# **Coshocton Port Authority Coshocton Collaborative**

### Addendum No. 3 – 19.137

December 11th 2023

.Harris/Day hitecture

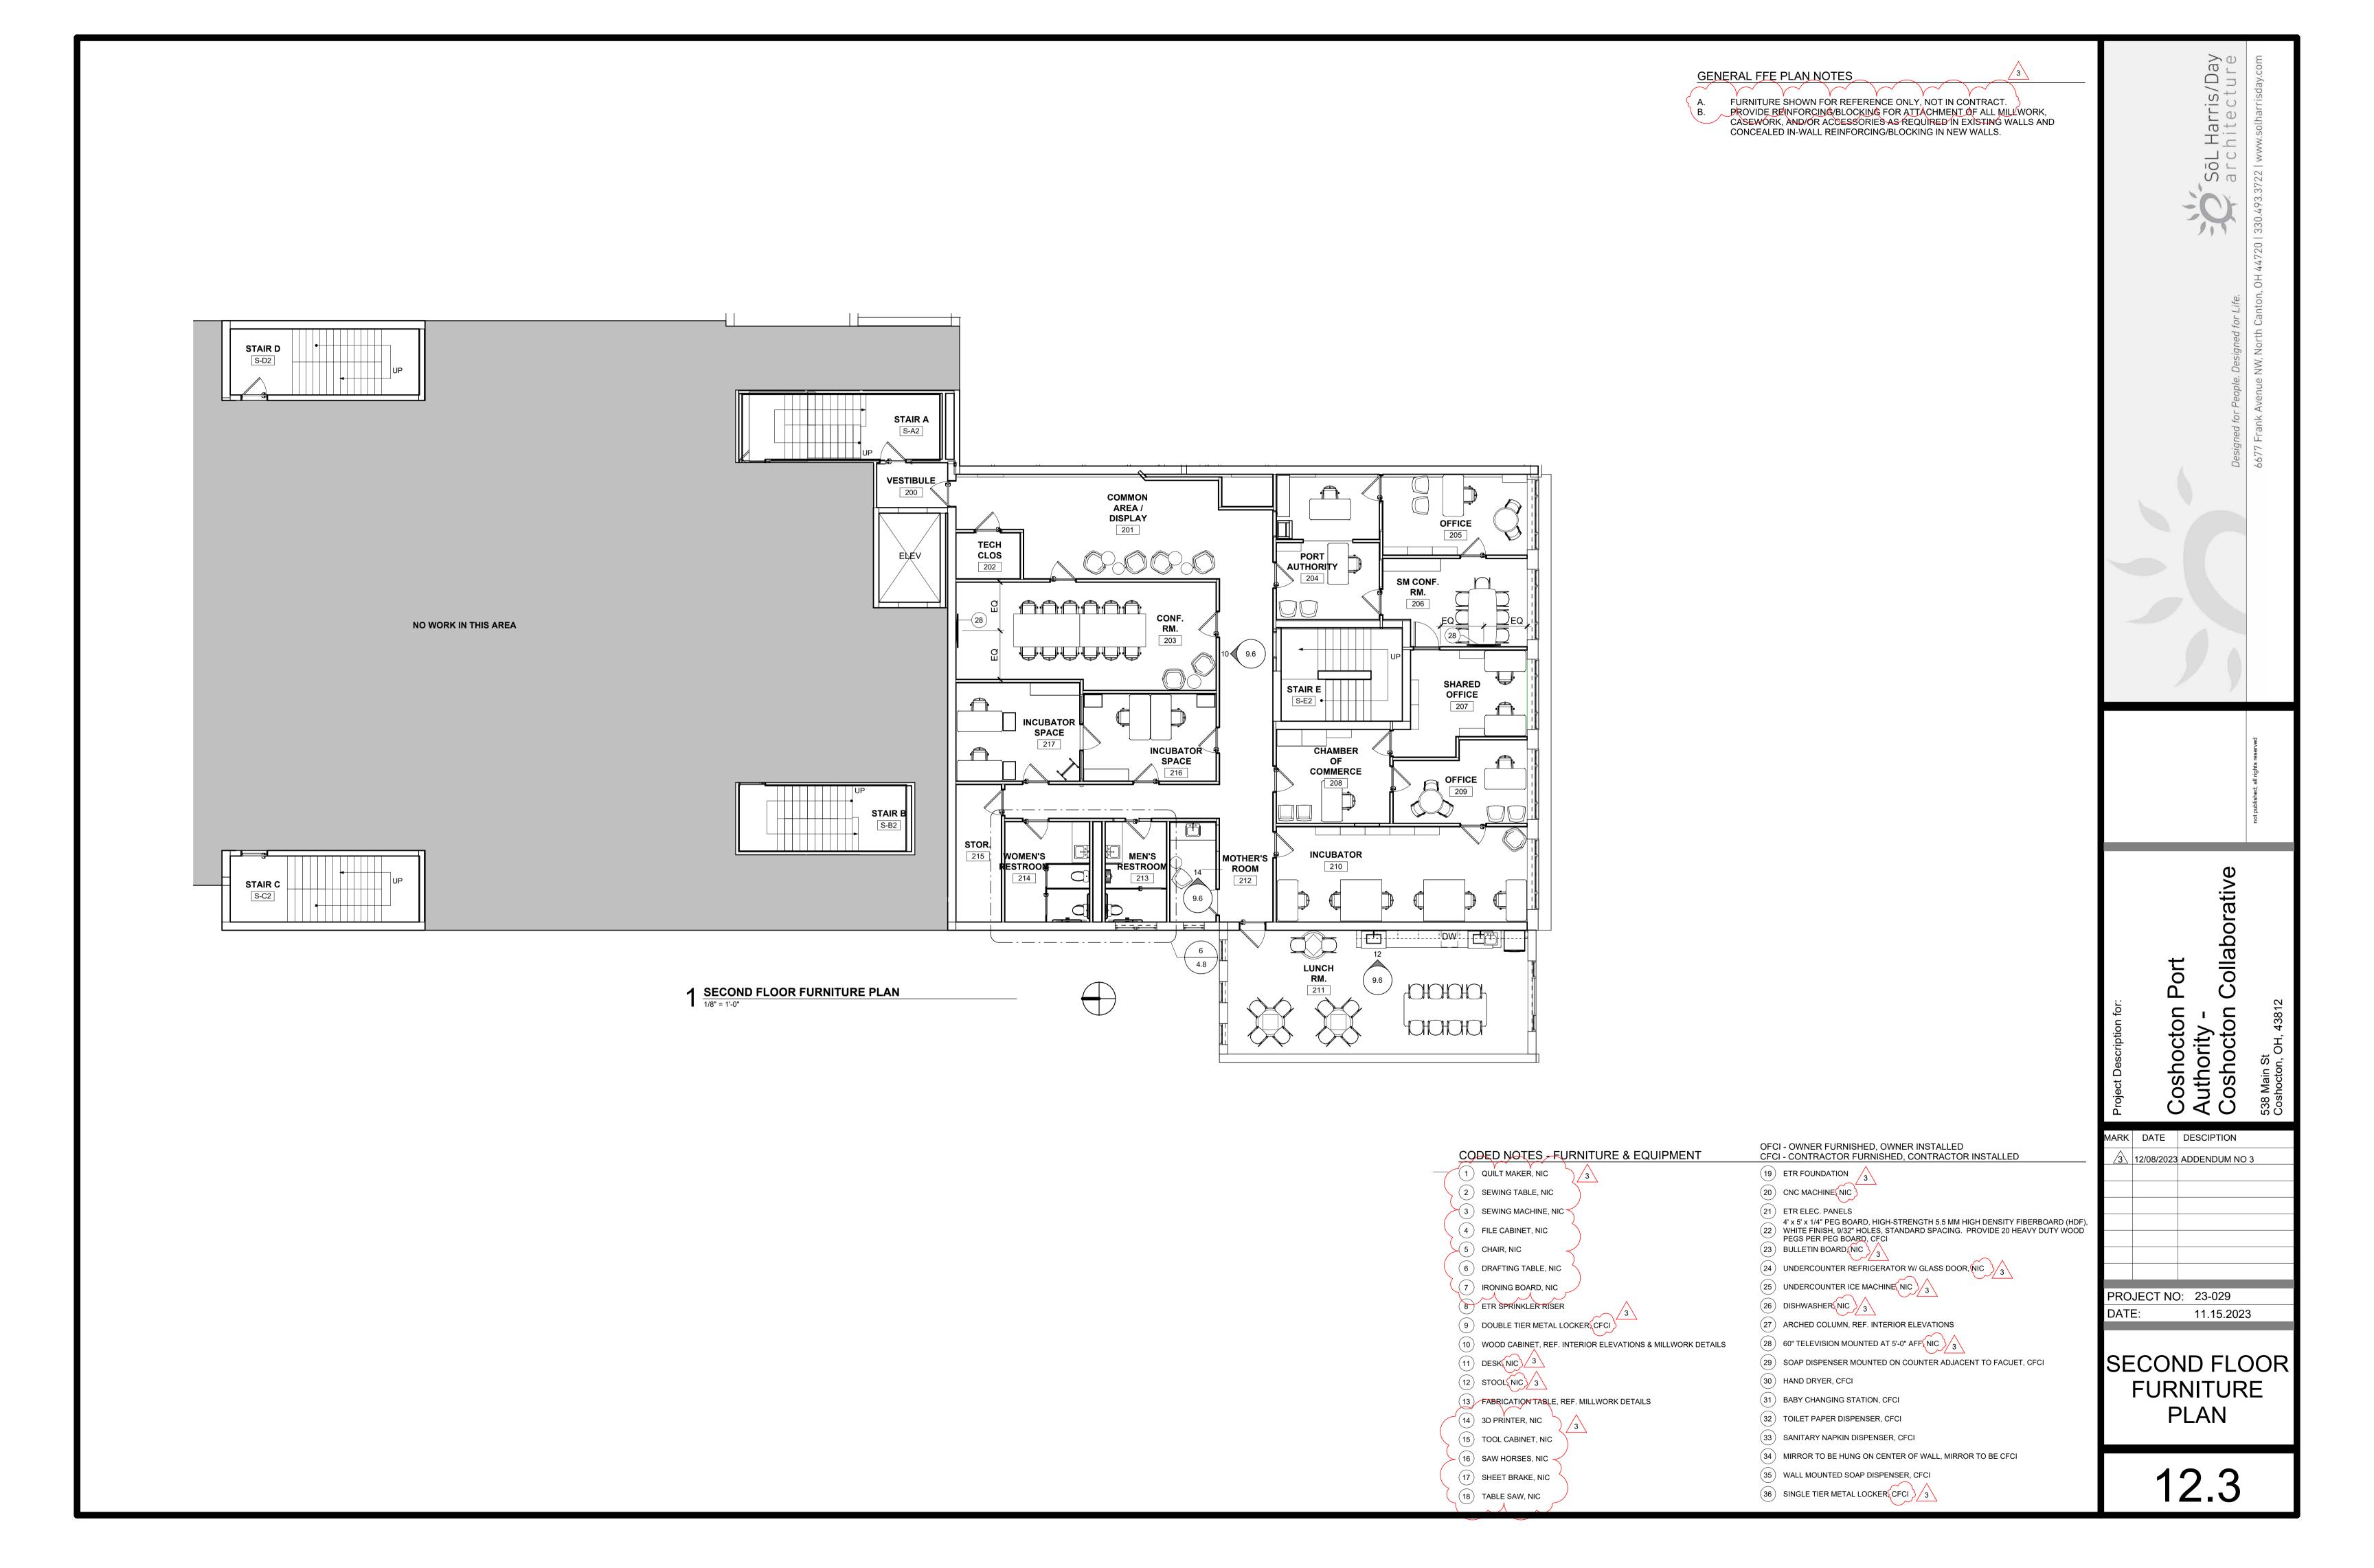
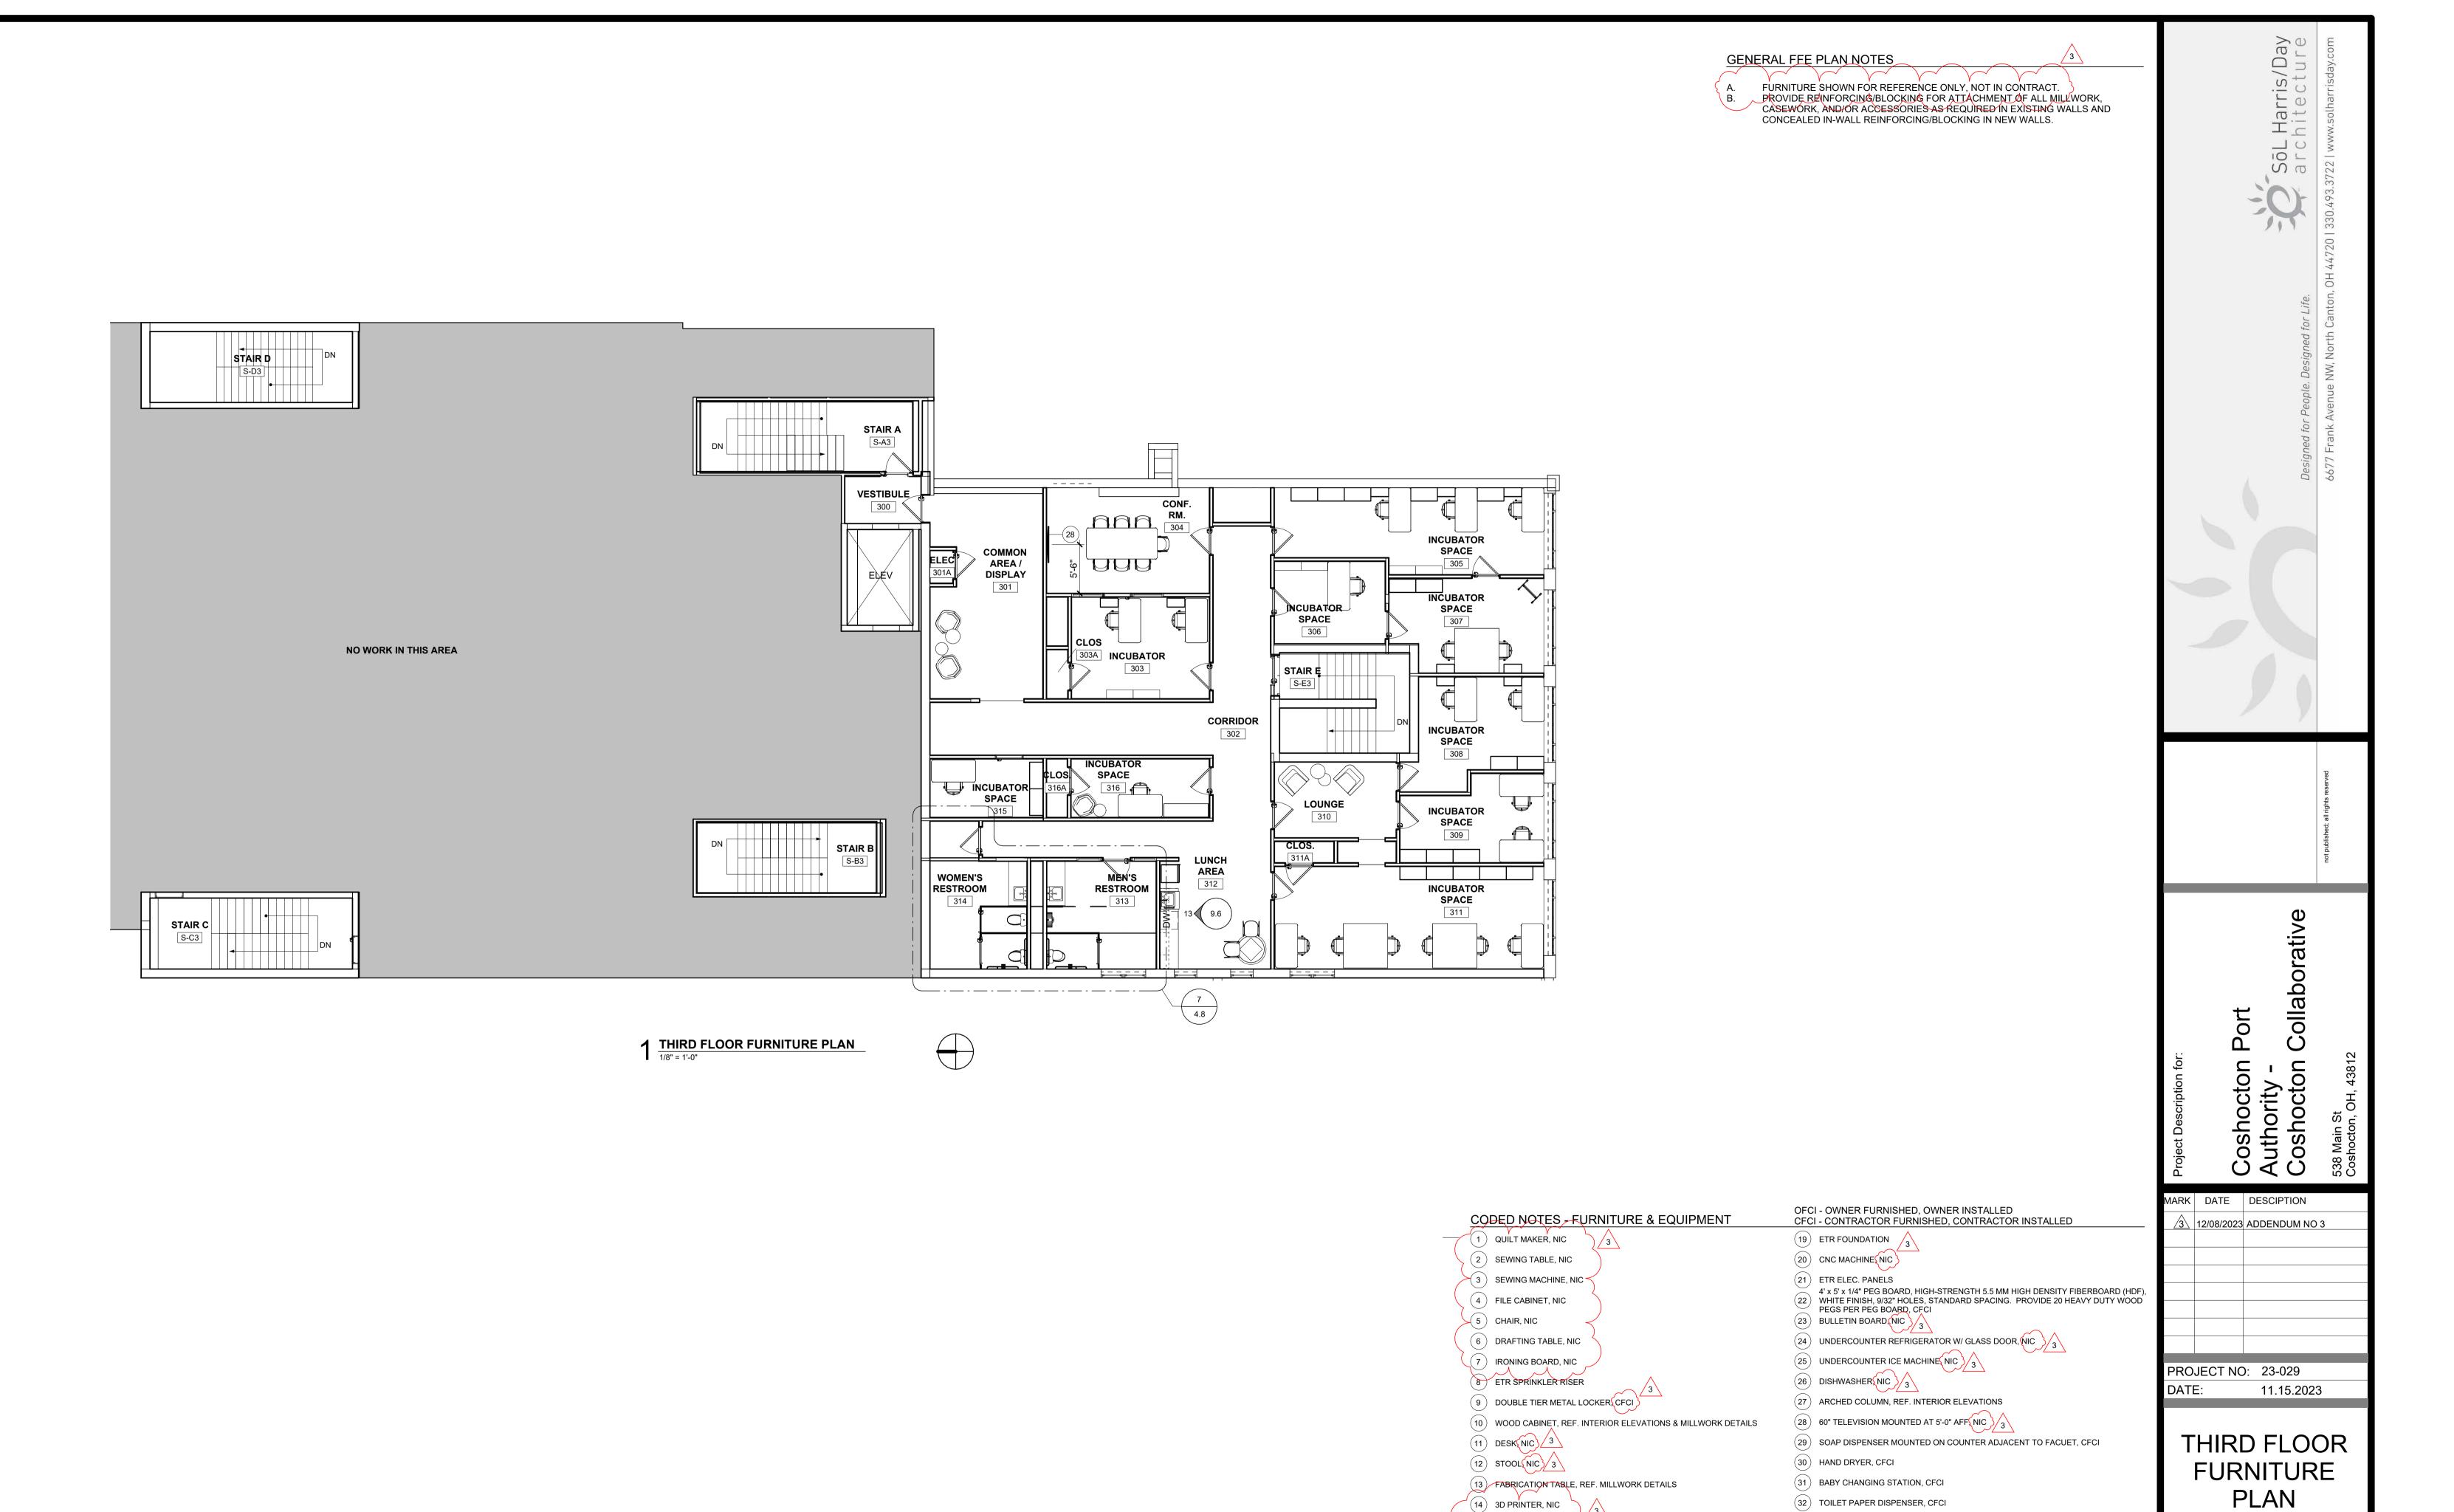
- b. Add SAU-2 Ceiling Baffle Typical Elevation 5.
- 4. 10.2 FIRST FLOOR REFLECTED CEILING PLAN
  - a. Dimension SAU-1
- 5. 12.1 BASEMENT FURNITURE PLAN
